From: Matt Dumont
To: Cheryl Low
CC:
Date: 14/09/2026
Subject: RFI responses for groundwater modelling

This response memo has been prepared to address the concerns raised in the submissions received on the modelling work undertaken for the Bendigo Ophir Gold Project. Documents considered in this response memo are:

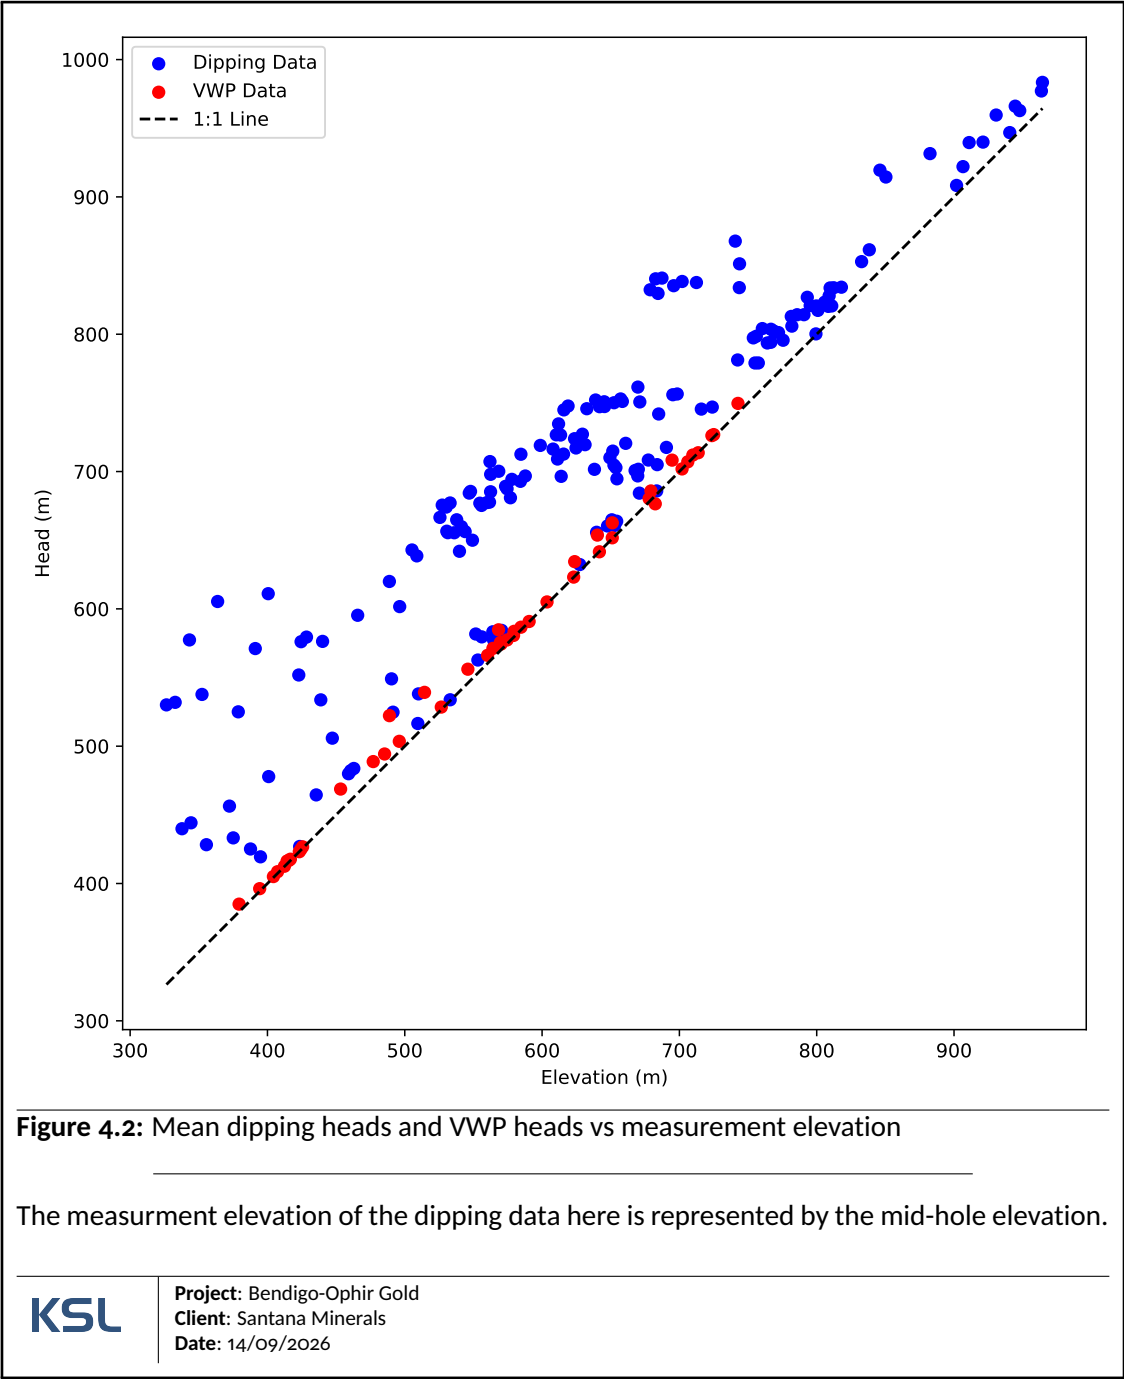
Finally, there were concerns that the model structure would bias discharge to the surface drains and therefore underestimate the potential for lost seepage. These concerns dominantly focused on the fact that vertical anisotropy could not be more than 1 (e.g., horizontal hydraulic conductivity is always greater than or equal to vertical hydraulic conductivity), the boundary conditions structure, and the structure of the OFFSHORE ("Off-shore" boundary to allow for seepage to flow out of the model domain) zone. The vertical anisotropy defines the sub-cell vertical anisotropy of the MODFLOW grid. The concern is that fracturing may yield preferential vertical flow pathways, particularly in the fresh schist. The weathered schist is unlikely to have preferential vertical flow on a large scale as the weathering process will be more present in the upper layers of the schist. Indeed, an assessment of the available hydraulic conductivity data for the weathered and fresh schist (figure A.9) shows decreasing hydraulic conductivity with depth, which is consistent with the weathering process. The presence of preferential flow pathways is a limitation of the modelling undertaken, but also there is no clear evidence that these preferential flow pathways exist. If having preferential vertical anisotropy was important to replicate the observed data, then the optimisation would have tightly constrained the posterior at the boundary (e.g., at 1). Figure 4.1 shows the prior and posterior distributions of the vertical anisotropy for the weathered schist and fresh schist. The results do not demonstrate a model optimisation that was significantly limited by the prior distribution limit. Therefore, we suggest that this decision is unlikely to significantly affect the predictive outputs of the model.

We disagree with the concern that the boundary condition structure biases flow to the surface drains. If we assume that the groundwater system is hydrologically contained to the valley (discussed in Section 5), then flow from the system cannot discharge:

The land surface drains accommodate pathways 1 and 2. Pathway 3 is accommodated in the shallow model by the presence of the weathered schist drains at the end of the Shepherds Creek gorge. In the deep model this pathway must be accommodated by the surface drainage at the end of the Shepherds Creek gorge (drain inverts at 400m). The final pathway is accommodated by the OFFSHORE zone. We suggest that the structure of the offshore zone is more likely to bias flow to the offshore zone than to the surface drains. The OFFSHORE zone is a DRN (Drain Boundary Condition), which means that it also is only a discharge point for the system. The inverts of the OFFSHORE DRN are at the top of the model cell ± 15 m (which is parameterised). Almost all measured groundwater dipping data and 80% of the VWP (Vibrating Wire Piezometer) data (revised, see [Section 6](#)) are above their measurement elevation ([Figure 4.2](#)). Therefore, setting the OFFSHORE DRN inverts at the top of the model cell is likely to be lower than the actual groundwater at that location. Additionally, the OFFSHORE DRN is located in every layer of the model (apart from layer 1 and 2), which means that the OFFSHORE DRN is the lowest discharge point in the model. Finally, the choice to remove layer 1 and 2 from the OFFSHORE zone was in part to ensure that no recharge from the surface could elevate groundwater levels in the OFFSHORE zone and reduce discharge to the OFFSHORE zone. Some flux may discharge to the surface rather than to the discharge zone in the deep model in Shepherds Creek gorge in the deep model only. However once the coupled model is included (e.g., for the prediction of interest), this flux will be captured by the drains in the weathered schist in the shallow model. The impacts of this partitioning is discussed further in [Section 11](#).

Figure 5.1: Pit, offshore and other discharges vs simulation type

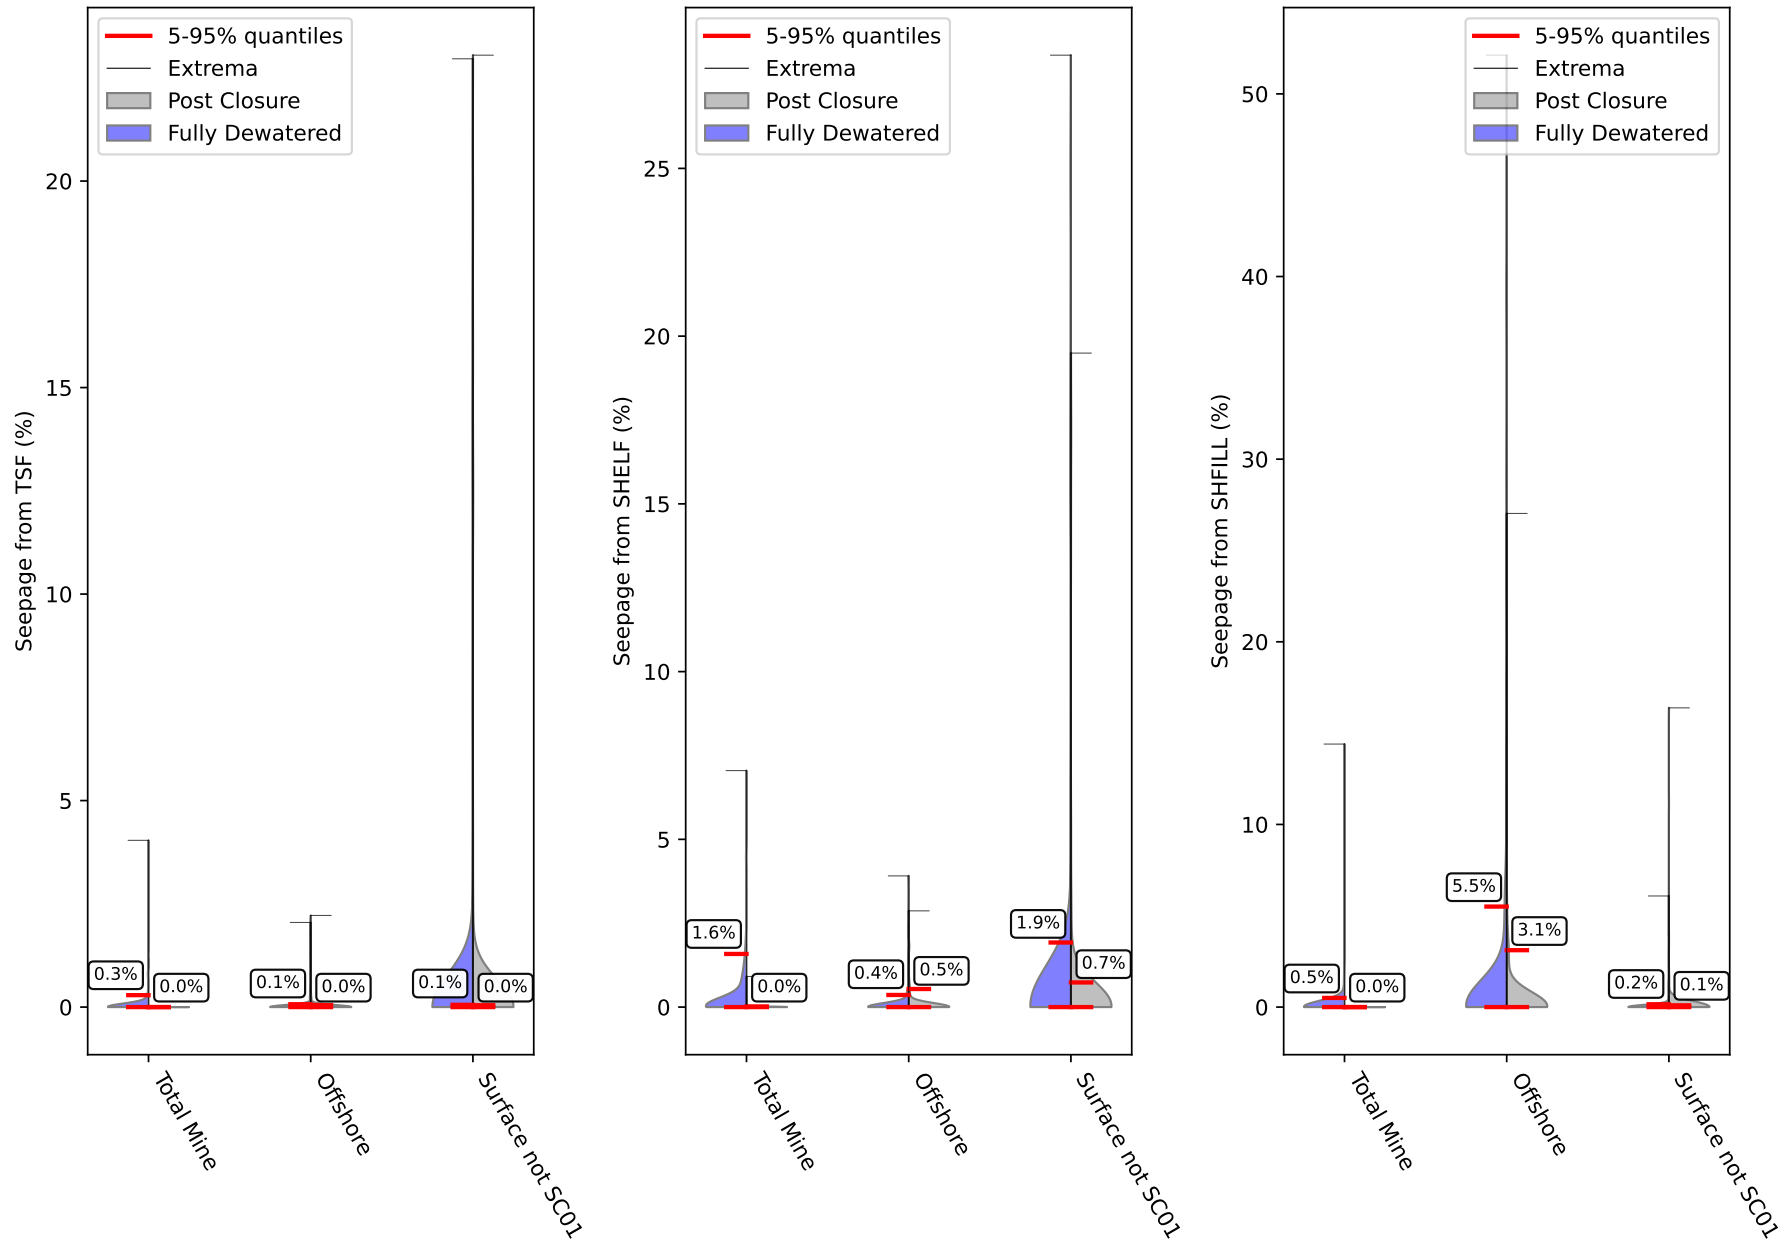
There is a further concern that dewatering of the RAS pit may cause a loss in the hydrological containment of the system. The RAS pit is located in the middle of the model domain, which would induce flow from the northern boundary to the pit, not the other way. Similarly, if the RAS pit dewatering causes a loss of containment to the South, then we would expect to see contaminant discharge into the surface drains in the Clearwater Creek area. No model realisations showed any discharge to this area. Loss of containment to the East is unlikely as this is upgradient of the RAS pit.

Our modelling did suggest some sensitivity of discharge to the RAS pit and OFFSHORE zone with increasing dewatering of the RAS pit. However, we note that the sensitivity of OFFSHORE to pit dewatering was generally quite low (predictor importance of < 0.025). The sensitivity of discharge to the RAS pit was somewhat higher (predictor importance of < 0.075). The discharged mass percentages to the RAS pit were generally low for most models. [Figure 5.1](#) shows the discharge to the RAS pit and OFFSHORE zone vs simulation type. There is minimal impact of full dewatering on the TSF lost seepage, but there is some increase in the SHFILL and SHELF lost seepage associated with the full dewatering of the RAS pit. These numbers are included in the full lost seepage assessment, but splitting them out here demonstrates the potential impacts of mine dewatering.

Note that the high seepage loss in the TSF Surface not SC01 in the violin plot is due to a failure of the kernel estimator. The 95th percentile is near zero for this factor.

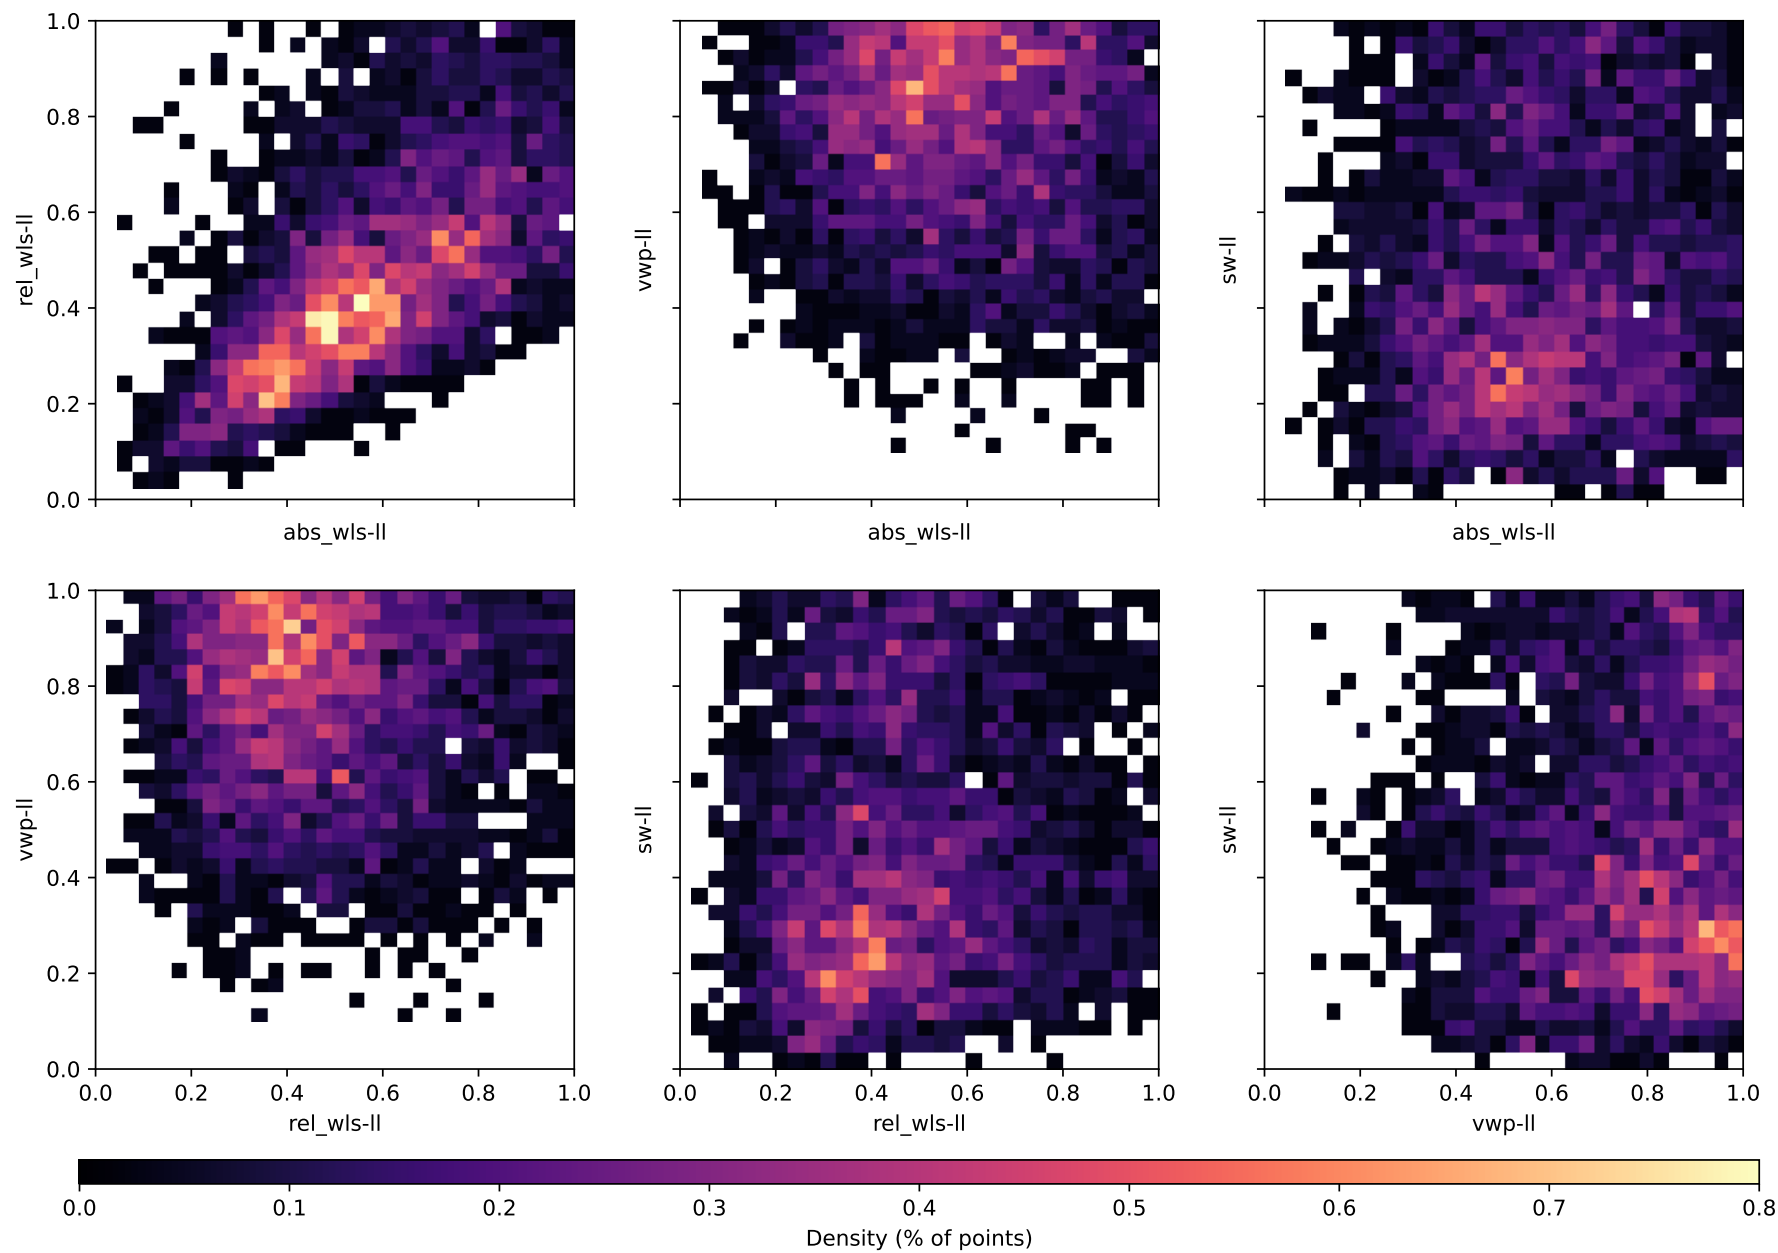
Morgan (2026) identified a discrepancy in the both the elevation and groundwater head of GWO4 and GWO5. We have investigated these discrepancies. The differences in the piezometer elevation are due to two factors. The first is a simplified approach undertaken in Burgess (2026) where an average dip and dip direction was used to calculate the VWP elevation in a dipping borehole. Our approach uses each individual survey step (e.g., 50.5 degrees from 5 to 10 m depth). This results in a discrepancy of approximately 2 m between the elevations used to calculate heads in Burgess (2026). There is also a typographical error in Burgess (2026), which means that incorrect elevation values were recorded. Note that we have confirmed with the author that this error only affects the reported VWP elevation in table 3 of Burgess (2026), and does not affect the reported groundwater head elevations in table 4.

To assess the impacts on the model, we have re-analysed the full suite of deep models with the revised VWP targets. The comparison between the components of the objective function for the revised VWP targets is shown in Figure 6.1. There is tension between the VWP and other head targets as shown by the lack of a relationship between the two objective function components. There will be some impacts on the relationship because the VWP targets were mis-optimised in the optimisation. However, we would expect some relationship between the two objective function components if they were both indicative of the same system. Given the strong 1:1 relationship of the VWP targets with depth, we suggest that the dipping and groundwater level surveys are a

more accurate representation of the system. The original deep model optimisation provided a good fit to both the dipping and groundwater level surveys, so we suggest that the model is still a good representation of the system.

Figure 8.1: Revised seepage estimates from consistent posterior distribution

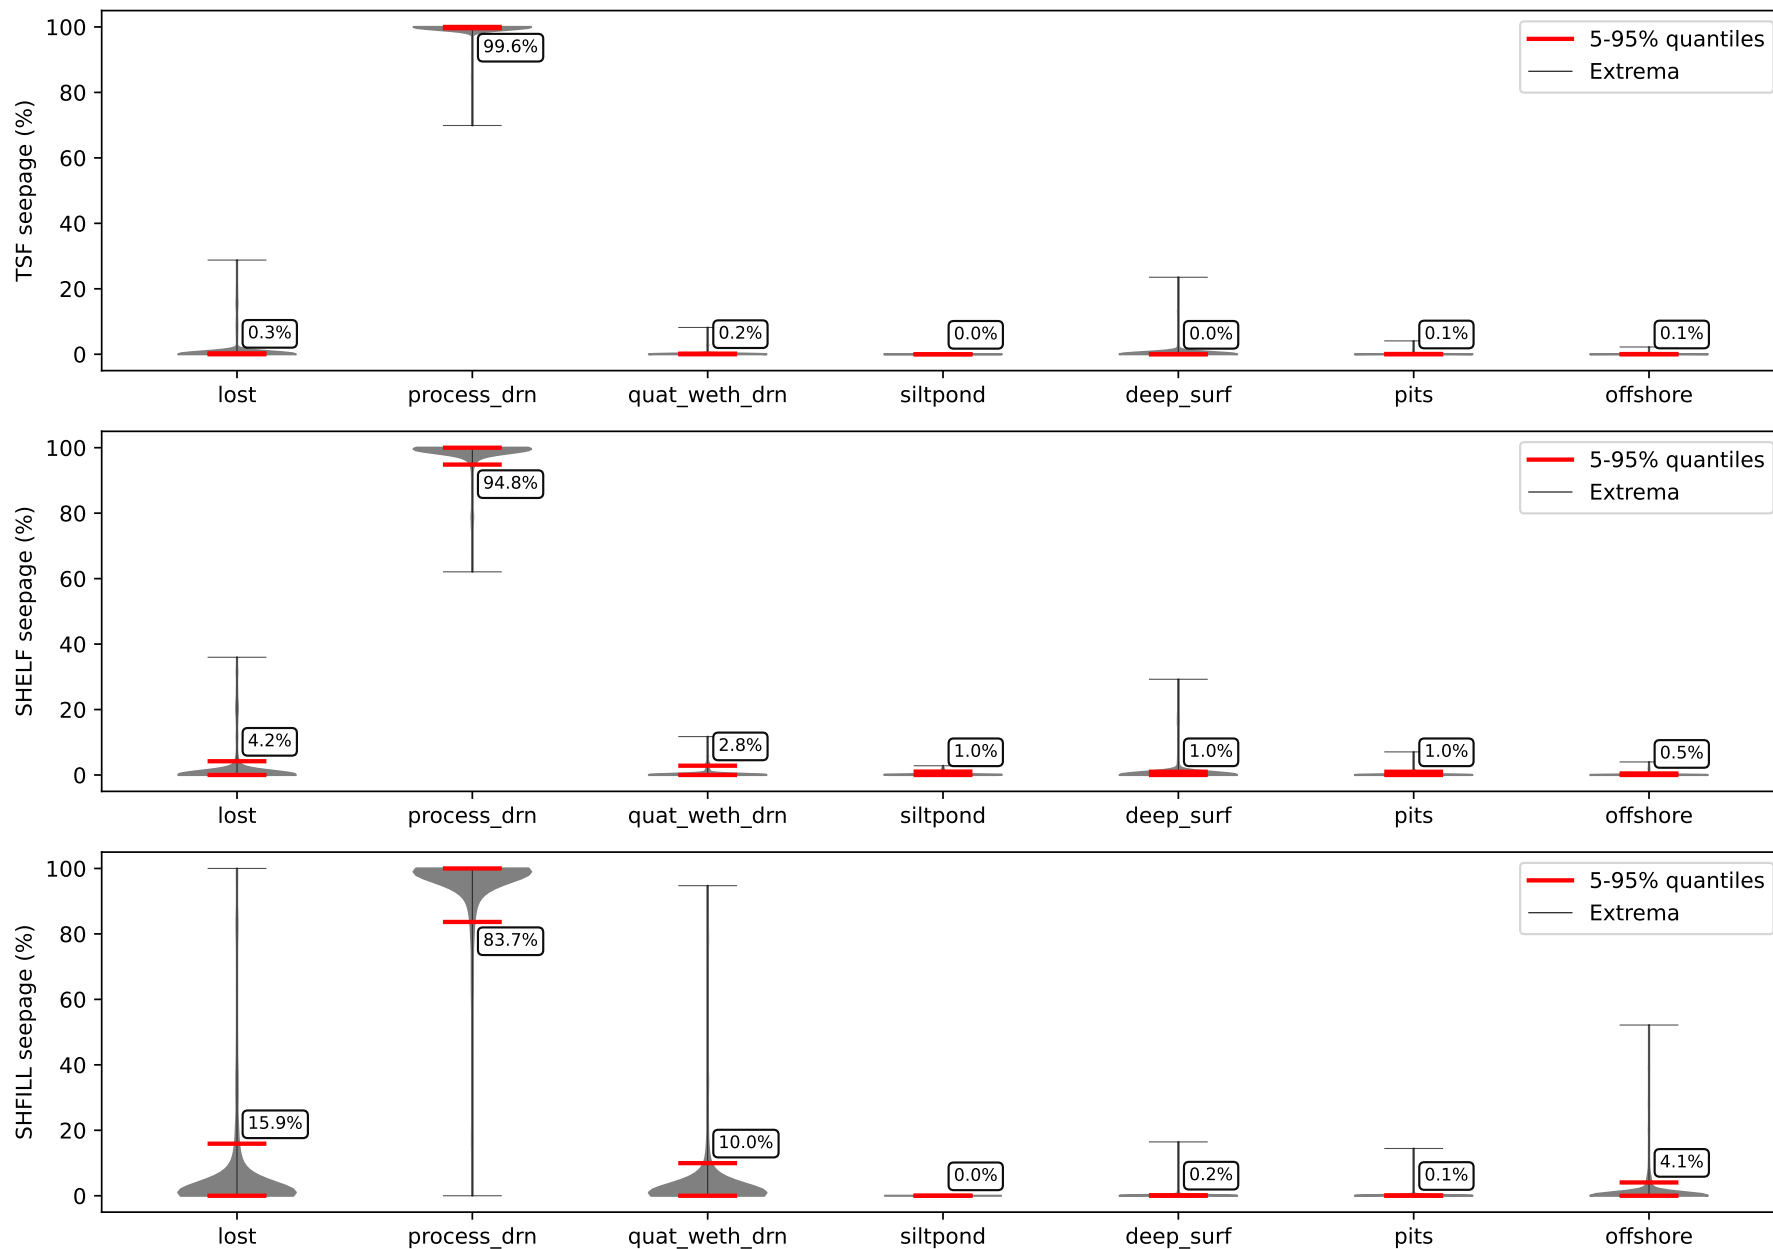
Due to time pressures, the assessment of lost seepage was undertaken using a componentwise approach. That is that each component of the seepage system was assessed independently and the posterior discharge distribution reported was not from the same posterior suite of model realisations. This was an oversight as the design characteristic of reduced hydraulic conductivity in the SUMP (Shepherds Creek Engineered Landform Seepage Collection Sump) was not applied to the SHFILL and TSF components of the seepage system.

To address this oversight, we created a consistent posterior distribution by filtering the full suite of model realisations for all design characteristics – heads in the TSF below 700 m, hydraulic conductivity of the weathered schist under the SUMP $< 1 \times 10^{-6} \text{ m/s}$, and the presence of the SHFILL underdrainage. The results of this filtering are shown in [Figure 8.1](#). The revised results show a significant reduction in lost seepage from the TSF. This occurs because the previous assessment of the TSF lost seepage did not include the design characteristic of the SUMP hydraulic conductivity, which serves to significantly control any seepage which is lost from the TSF. There is also a slight reduction in the lost seepage from the SHELF. The 95th percentile decreases from the previous value, but the distribution is relatively unchanged. Essentially the filtering of the TSF heads removes several outliers, which then serves to reduce the 95th percentile of the SHELF lost seepage. This is an example of the sensitivity of upper percentiles to outliers in the distribution. SHFILL lost seepage 95th percentile is increased from c. 10% to c. 15%. This is most likely due to the reduced number of realisations, but also may be affected by the reduced losses from the TSF and SHELF components of the seepage system (e.g., SHFILL water replaces the TSF/SHELF water). While an increase in the SHFILL lost seepage may seem concerning, the contaminant production from and recharge area of the SHFILL is significantly lower than the TSF and SHELF components of the seepage system. So the increase in the SHFILL lost seepage in the context of decreased lost seepage from the TSF and SHELF components of the seepage system likely yields a net decrease in the total contaminant load to the receiving environment. This is further discussed in [Section 12](#)

The values presented here differ from those presented in the report as they are based on a consistent posterior distribution defined by: heads in the TSF below 700 m, hydraulic conductivity of the weathered schist under the SUMP $< 1 \times 10^{-6} \text{ m/s}$, and the presence of the SHFILL underdrainage.
